Rezoning Transportation Analysis

Petition Number: 2019-029

Date	Description
03-21-2019	First Review
05-07-2019	Second Review

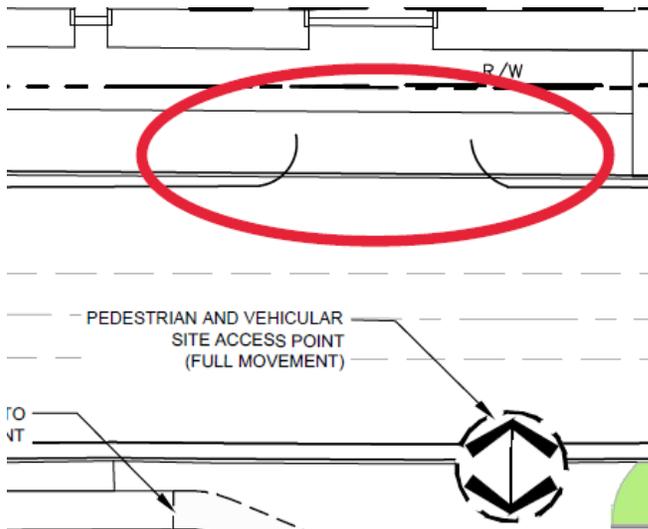
- i. Pedestrian refuge island on the southwest corner
 - ii. Upgrade all accessible ramps and pedestrian signals at intersection
3. ~~The petitioner should revise the site plan to include all existing driveways along East 7th Street and North Caswell Road in the existing right-of-way. CDOT cannot verify the location of the driveway shown in the picture below.~~
